**IEEE PES TRANSFORMERS COMMITTEE**  
**DIELECTRIC TEST SUBCOMMITTEE**

Dielectric Tests Subcommittee		
<b>Chair: Poorvi Patel</b>	<b>Vice-Chair: Thang Hochanh</b>	<b>Secretary: Diego Robalino</b>
<b>Room: Century C</b>	<b>Date: Wednesday, October 25<sup>th</sup>, 2023</b>	<b>Time: 11:00 am to 12:15 pm</b>
Total DTSC Members: <b>133</b>	Members present at the meeting: <b>98</b>	Attendance according to sign in sheet: <b>222</b>
Guests present: <b>124</b>	Membership requested: <b>17</b>	Membership accepted: <b>12</b>
Members moved to Guest Status: <b>44</b>

## **TF Revision to Low Frequency Dielectric Tests**

## **Task Force on Revision of Impulse Tests**

Figure 1—Typical lightning impulse circuit

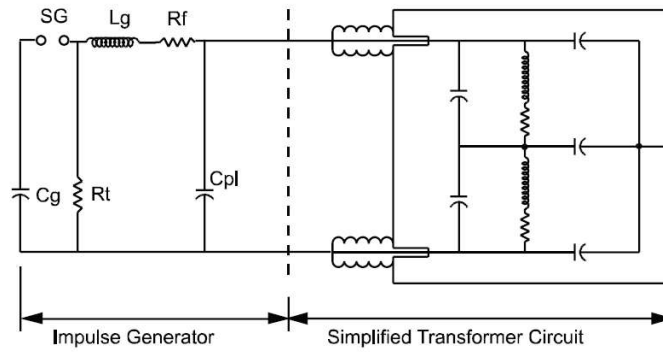
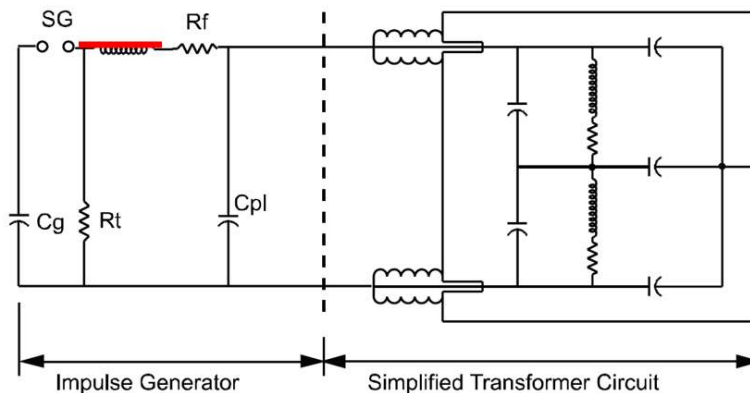
Group discussed and agreed to change the figure as follows. Did not vote as the chair promised to clean up the figure and add the below notes before the next meeting and the vote:

Remove Lg from all figures with impulse circuits that has the Lg.  
Change SG to IG on all figures related to impulse circuit.  
Add the voltage divider block to all figures related to ...

Figure 2—Typical transformer connection for routine impulse testing

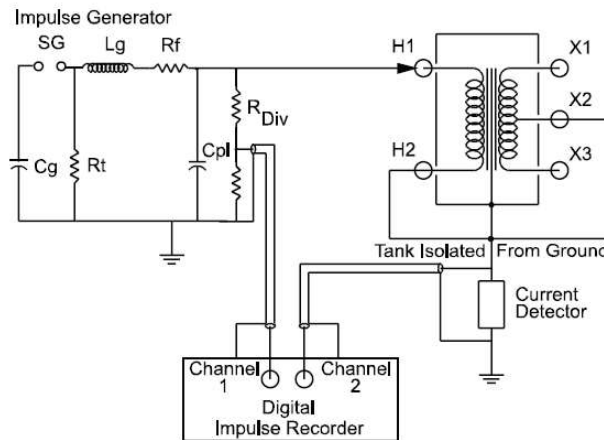
Group verbally agreed to make the similar changes as for figure-1 and then remove the below sentence from the paragraph.

The voltage divider and digital impulse recorder connection, as shown in Figure 2 was figure 3 through Figure 20.

Figure 3—Maximum sensitivity connection

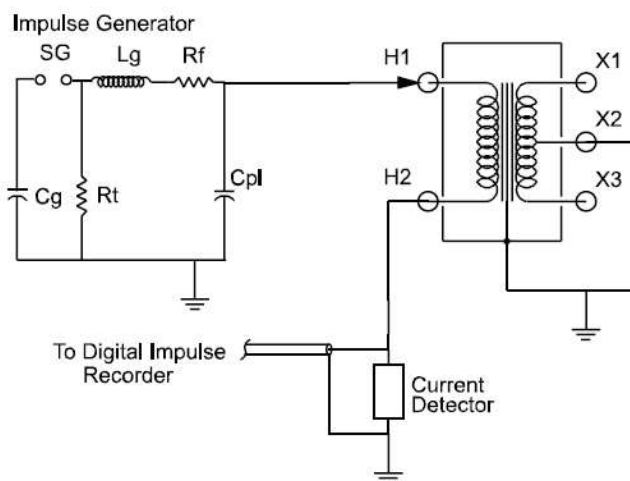
Group verbally agreed to make the voltage divider a block for both this and add to fig 3 on the following section for figure-3

Group continued to review all figures thru 17. Agreed all requires some changes. Revise 6.2.3.3 and match the figures 14 and 15 to the new revised paragraph. Revise 6.2.3.4 and match the figures 16 and 17 to the new revised paragraph

Figure 1 The high magnitude oscillation after the peak value resulted in missing the chopping at 3.5  $\mu$ s, the late chopping occurred at 6.0  $\mu$ s; due to excessive oscillation the voltage dropped by 70 kV or 48% at 4.2  $\mu$ s;

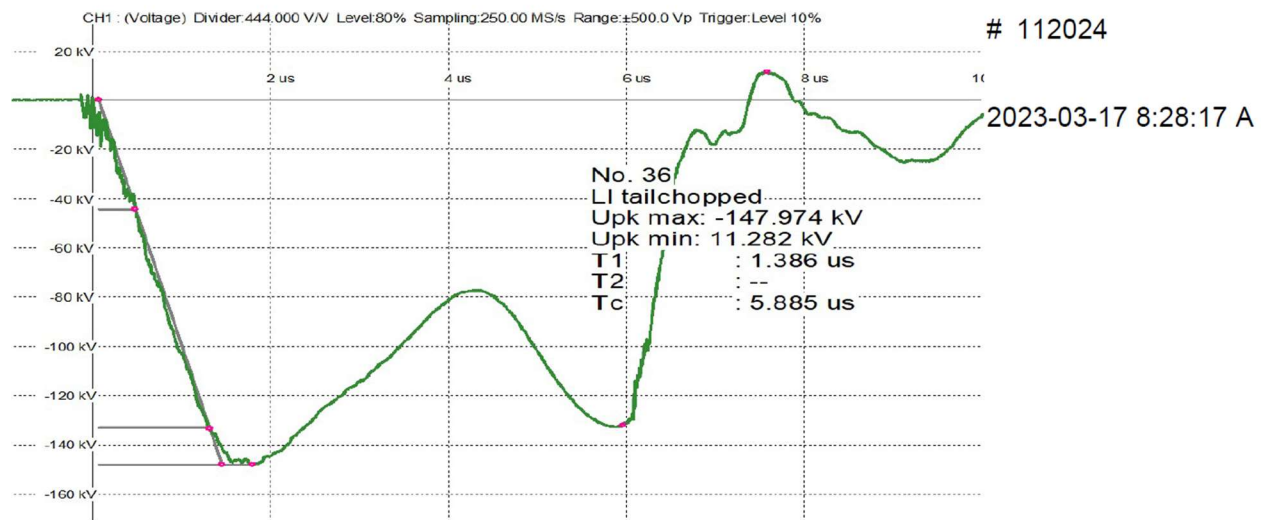
When the voltage waveform has excessive, high magnitude oscillations immediately following the peak value, the chopper may miss the designated chopping time,  $T_c$ , due to a large voltage derivative in time,  $dV/dt$ , or a change of its sign. This may lead to: (i) late chopping, passed the targeted chopping time value, often producing high oscillations within and between the windings, (ii) failure to chop, producing a full wave with 110% LI value, overstressing the transformer insulation.

The example of a CW event with a late chopping on the waveform with a deep valley of 48% of the peak value, is shown in the Figure 1 below.

The problem with late, or no chopping may occur on the windings with low impedance. If the chopper electronic circuit cannot perform a chop at required chopping time, despite checking different setup configurations, including but not limited to , series gaps , additional capacitance, etc. the use of a conventional chopping gap (rod-rod gap) may solve the problem.

Fig.2. An example of deep valley with lower magnitude: the voltage dropped by 42 kV or 20% at 1.9 μs

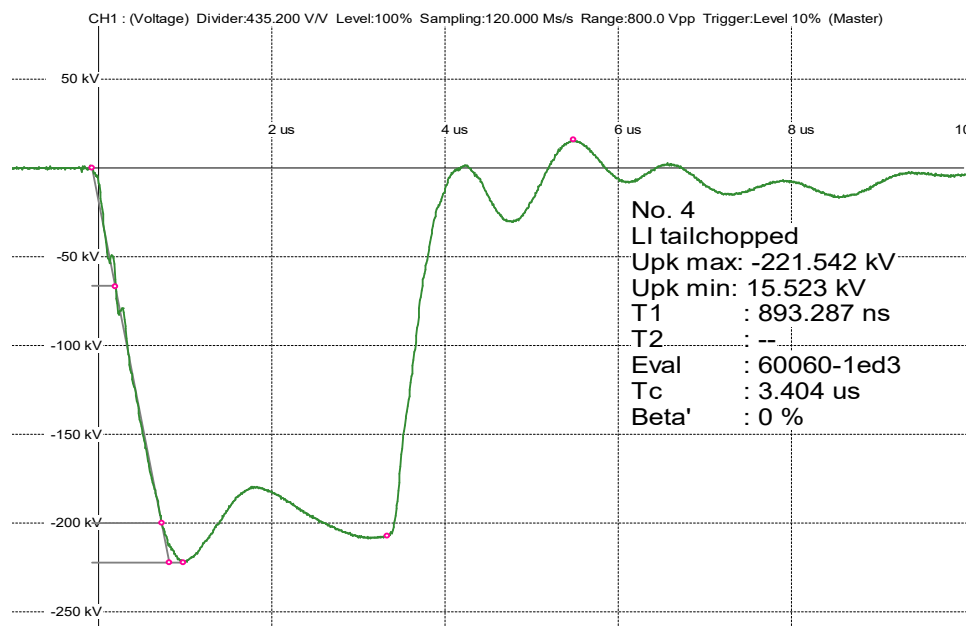
When the oscillation doesn't have excessive magnitude the chopping is successful, as shown in Fig.2 with a valley of 20% of the peak value.
